December 2, 1977

The Commission has issued the enclosed Amendments Nos. 35 and 34 to Facility Operating Licenses Nos. DPR-32 and DPR-37 for the Surry Power Station, Units Nos. 1 and 2, respectively. These amendments include changes to the Technical Specifications for each license in response to your application dated August 9, 1977, as supplemented August 26, 1977, October 14, 1977, and November 16, 1977.

These amendments establish peaking factors  $[F_0(Z)]$  to be used when the steam generator tube plugging limit exceeds 19% for Surry Unit No. 1 and 20% for Surry Unit No. 2; in addition, a tube plugging limit of 25% is authorized for both units.

AMENDMENT TO FACILITY OPERATING LICENSE

FIGURE 2.1-1 REACTOR CORE THERMAL & HYDRAULIC SAFETY LIMITS-  
THREE LOOP OPERATION, 90% DESIGN FLOW

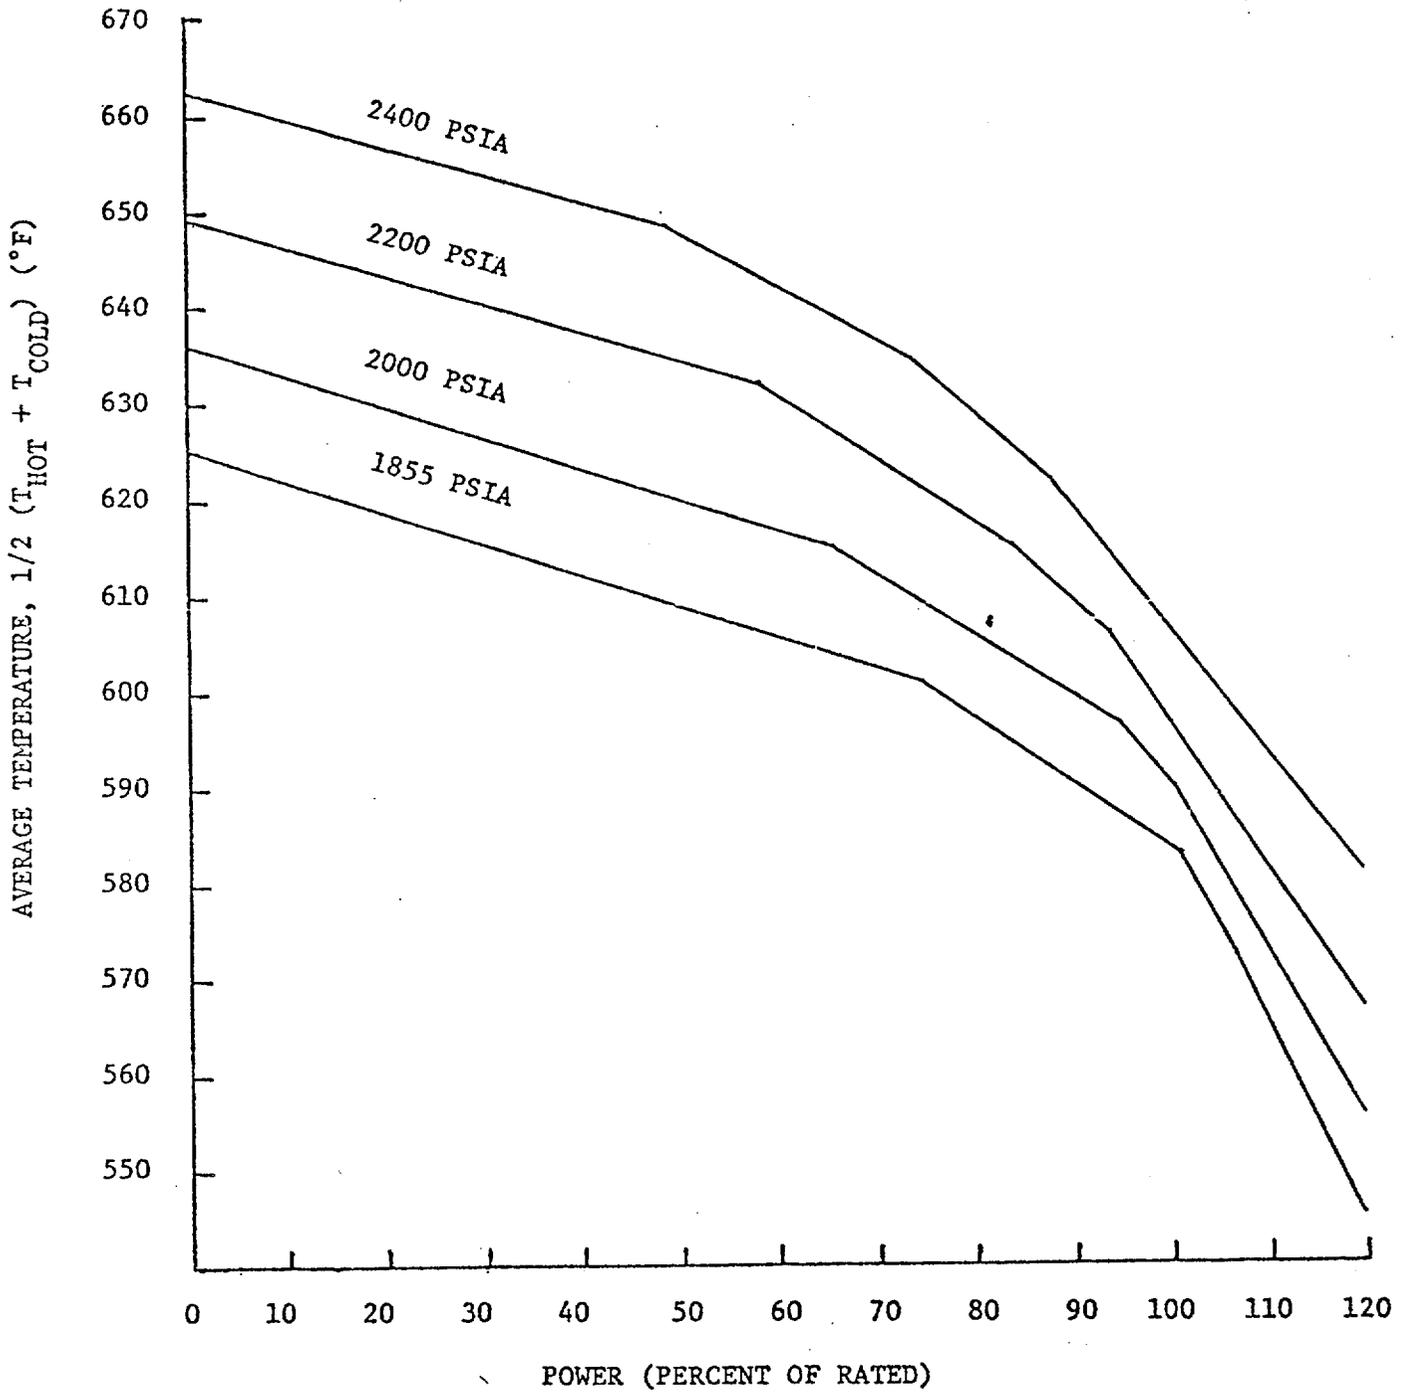
The curves of TS Figure 2.1-1 which show the allowable power level decreasing with increasing temperature at selected pressures for constant flow (three loop operation) represent limits equal to, or more conservative than, the loci of points of thermal power, coolant system average temperature, and coolant system pressure for which the DNB ratio is equal to 1.30 or the average enthalpy at the exit of the core is equal to the saturation value. The area where clad integrity is assured is below these lines. The temperature limits are considerably more conservative than would be required if they were based upon a minimum DNB ratio of 1.30 alone but are such that the plant conditions required to violate the limits are precluded by the self-actuated safety valves on the steam generators. The three loop operation safety limit curve has been revised to allow for heat flux peaking effects due to fuel densification and to apply to 90% of design flow. The effects of rod bowing are also considered in the DNBR analyses.

- A. The combination of reactor thermal power level, coolant pressure, and coolant temperature shall not:
1. Exceed the limits shown in TS Figure 2.1-1 when 90% of design flow from three reactor coolant pumps exist.
  2. Exceed the limits shown in TS Figure 2.1-2 when full flow from two reactor coolant pumps exist and the reactor coolant loop stop valves in the non-operating loop are open.
  3. Exceed the limits shown in TS Figure 2.1-3 when full flow from two reactor coolant pumps exist and the reactor coolant loop stop valves in the non-operating loop are closed.

HOT CHANNEL FACTOR NORMALIZED

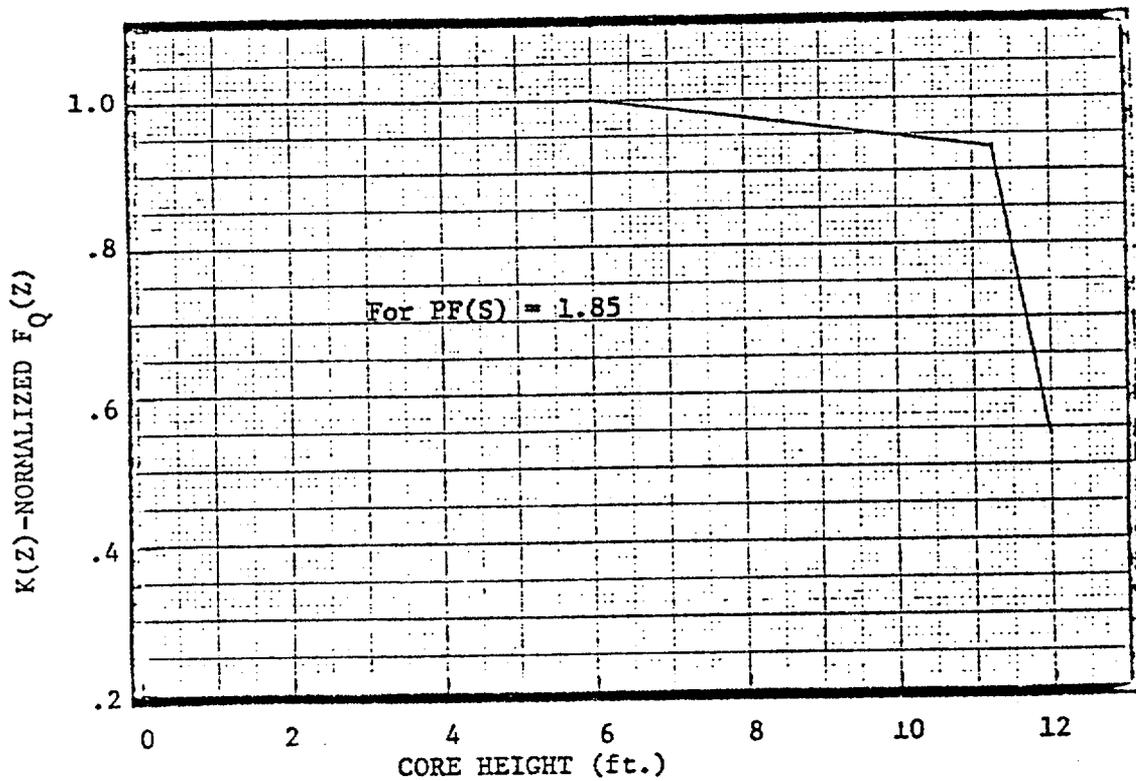
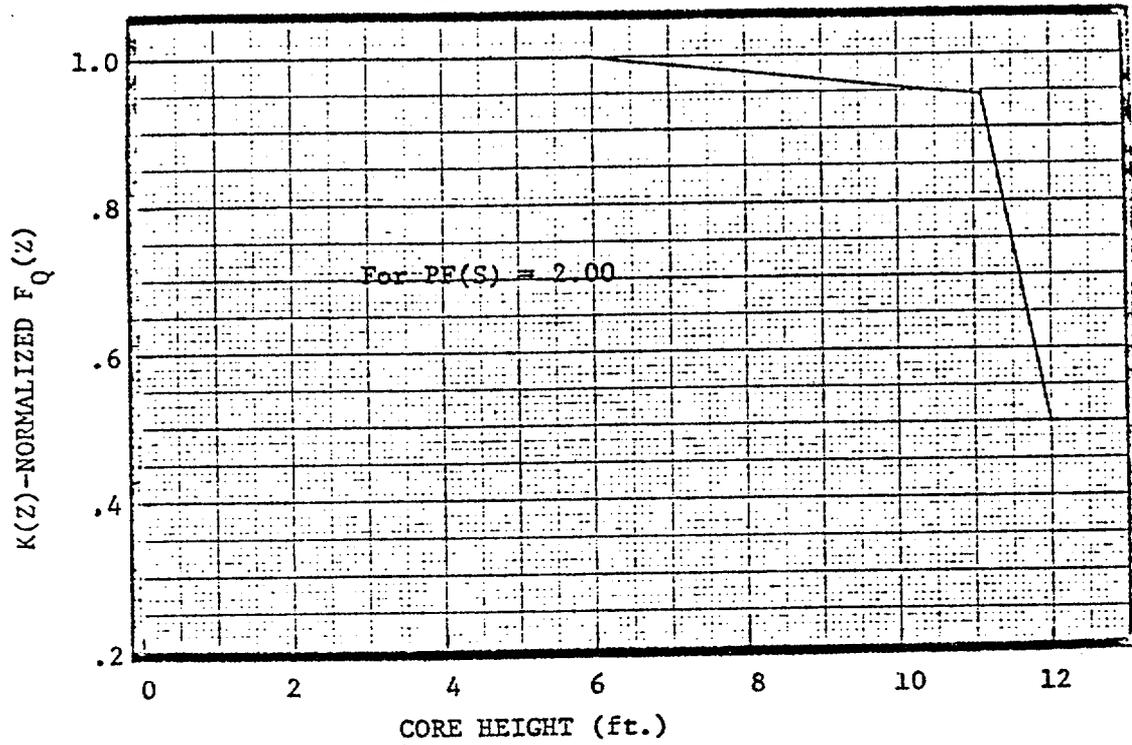
DELETE

FIGURE 2.1-1 REACTOR CORE THERMAL & HYDRAULIC SAFETY LIMITS-  
THREE LOOP OPERATION, 90% DESIGN FLOW

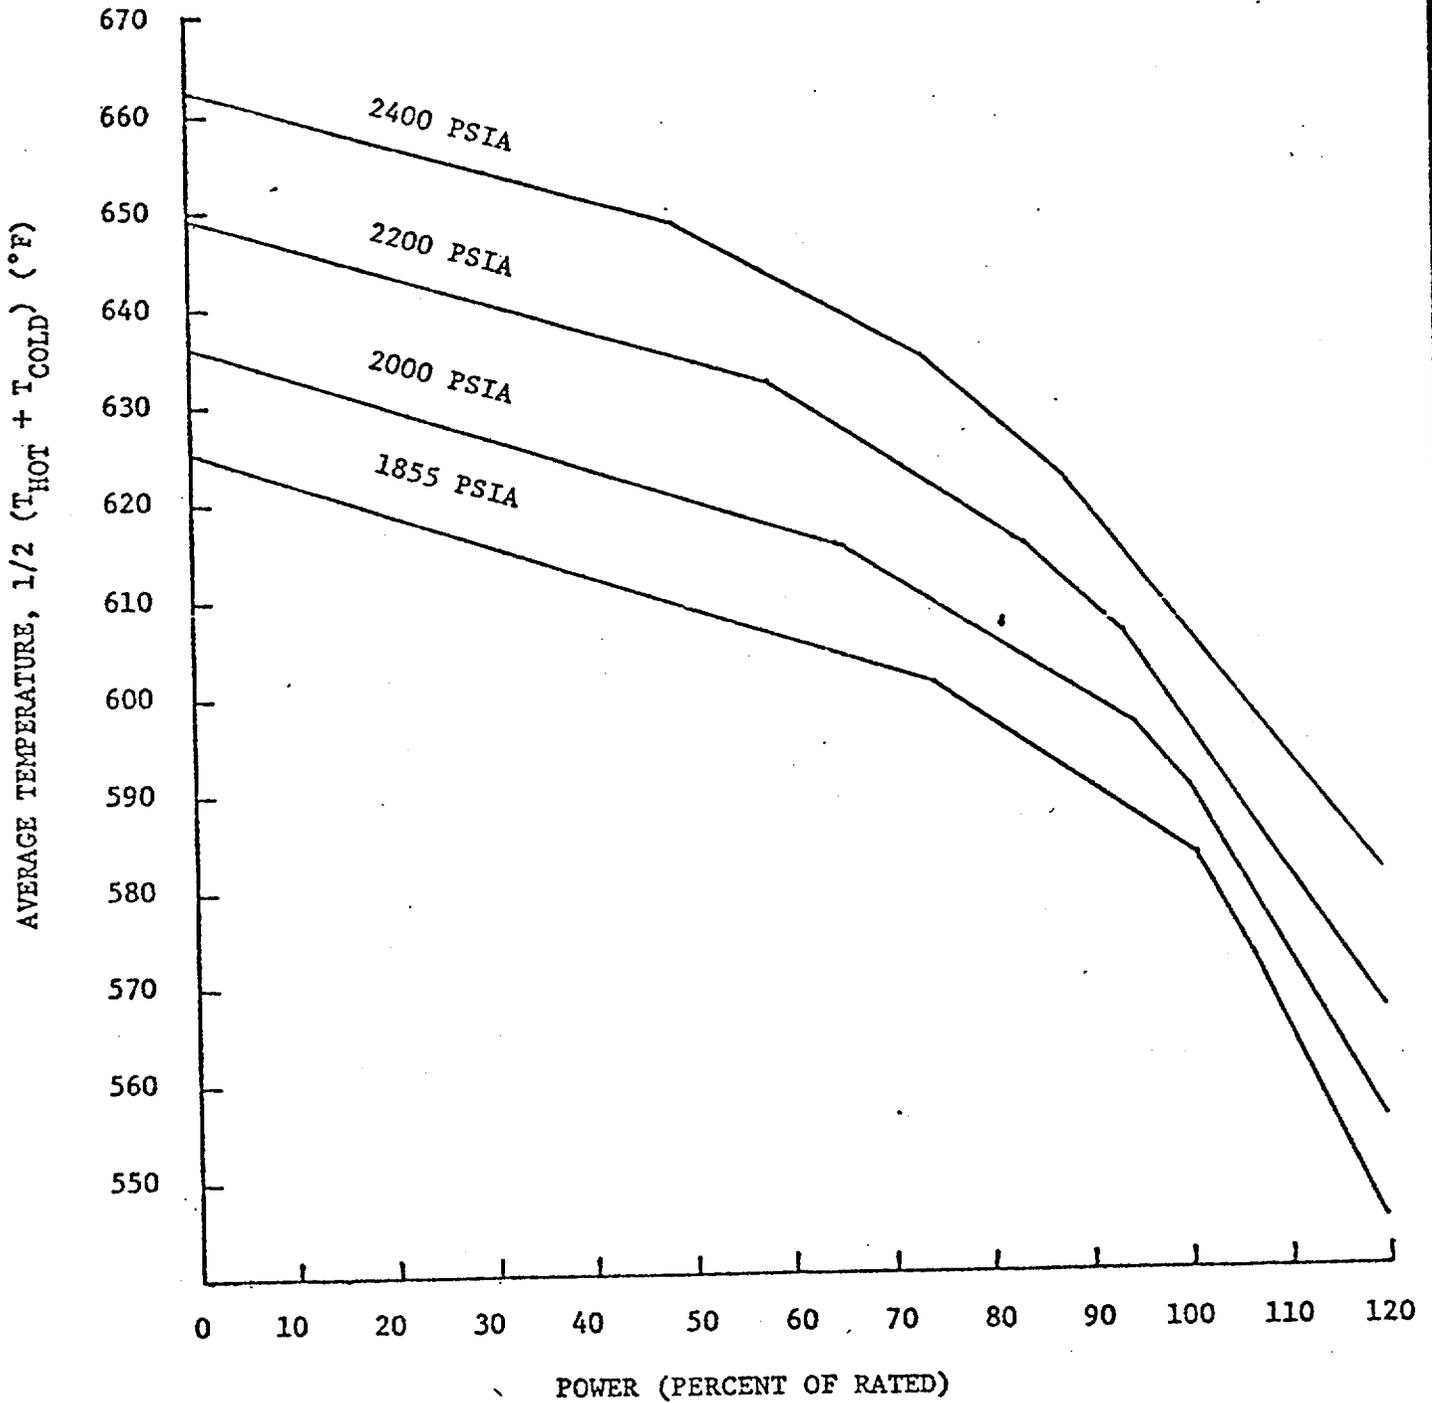
The curves of TS Figure 2.1-1 which show the allowable power level decreasing with increasing temperature at selected pressures for constant flow (three loop operation) represent limits equal to, or more conservative than, the loci of points of thermal power, coolant system average temperature, and coolant system pressure for which the DNB ratio is equal to 1.30 or the average enthalpy at the exit of the core is equal to the saturation value. The area where clad integrity is assured is below these lines. The temperature limits are considerably more conservative than would be required if they were based upon a minimum DNB ratio of 1.30 alone but are such that the plant conditions required to violate the limits are precluded by the self-actuated safety valves on the steam generators. The three loop operation safety limit curve has been revised to allow for heat flux peaking effects due to fuel densification and to apply to 90% of design flow. The effects of rod bowing are also considered in the DNBR analyses.

- A. The combination of reactor thermal power level, coolant pressure, and coolant temperature shall not:
1. Exceed the limits shown in TS Figure 2.1-1 when 90% of design flow from three reactor coolant pumps exist.
  2. Exceed the limits shown in TS Figure 2.1-2 when full flow from two reactor coolant pumps exist and the reactor coolant loop stop valves in the non-operating loop are open.
  3. Exceed the limits shown in TS Figure 2.1-3 when full flow from two reactor coolant pumps exist and the reactor coolant loop stop valves in the non-operating loop are closed.

HOT CHANNEL FACTOR NORMALIZED

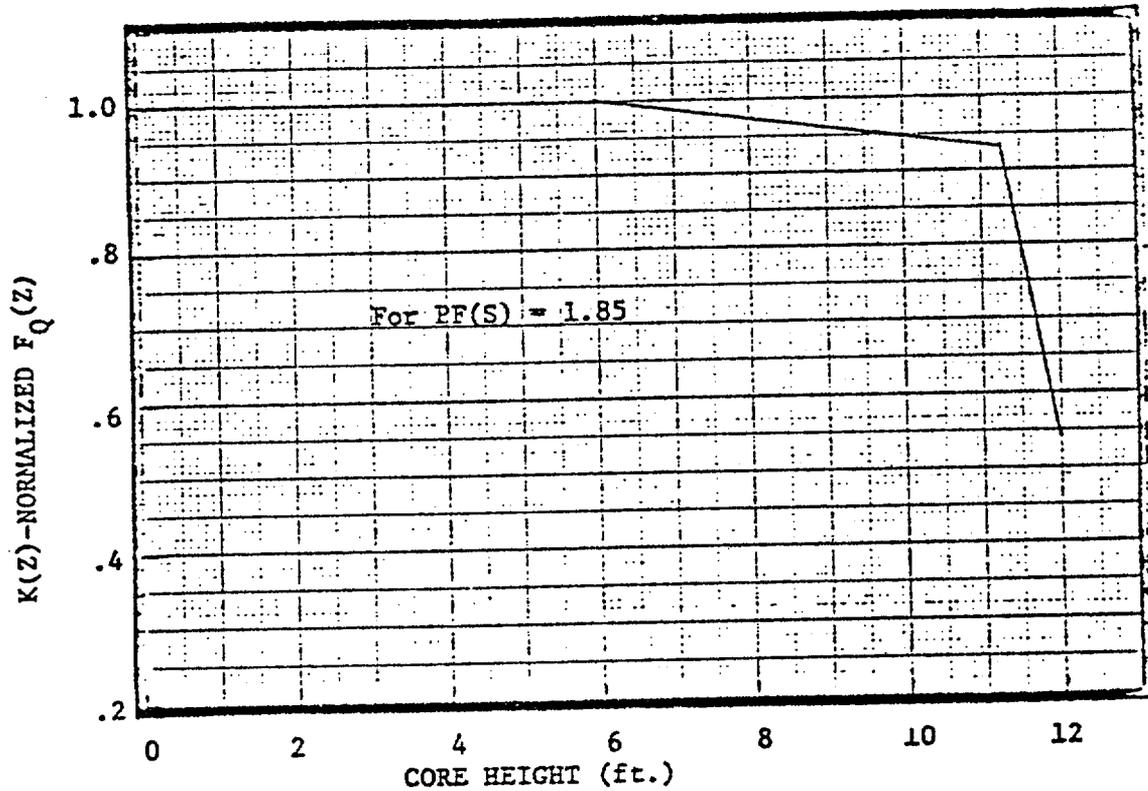
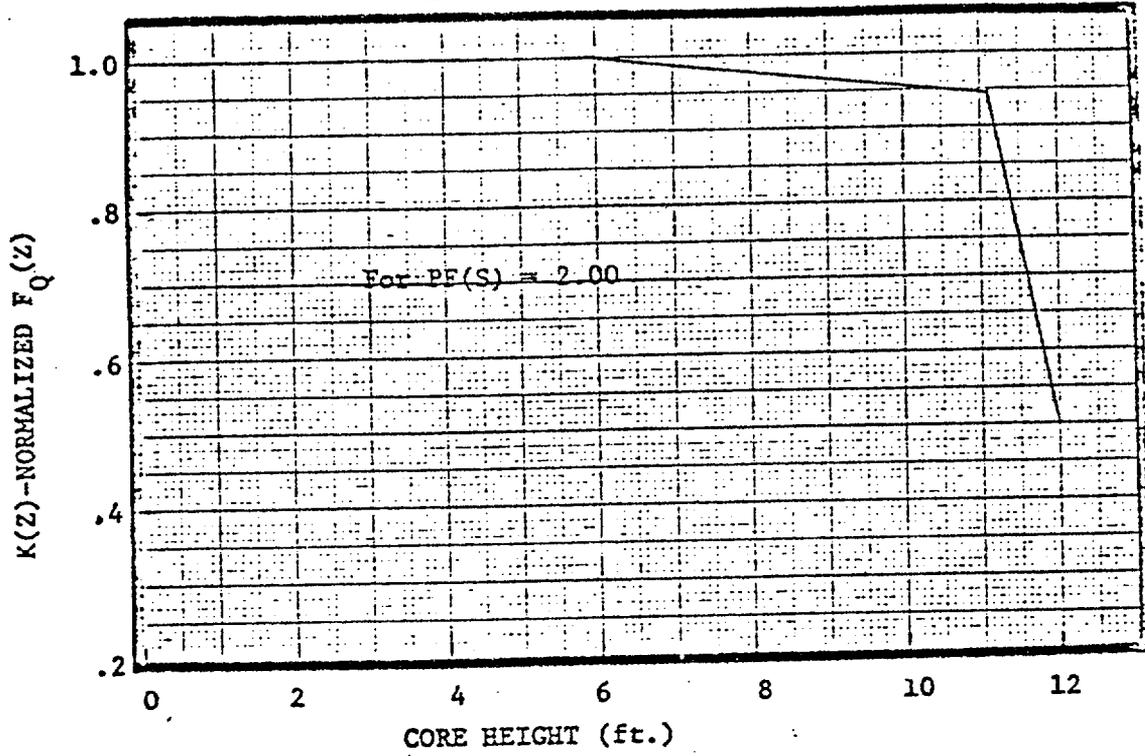
DELETE
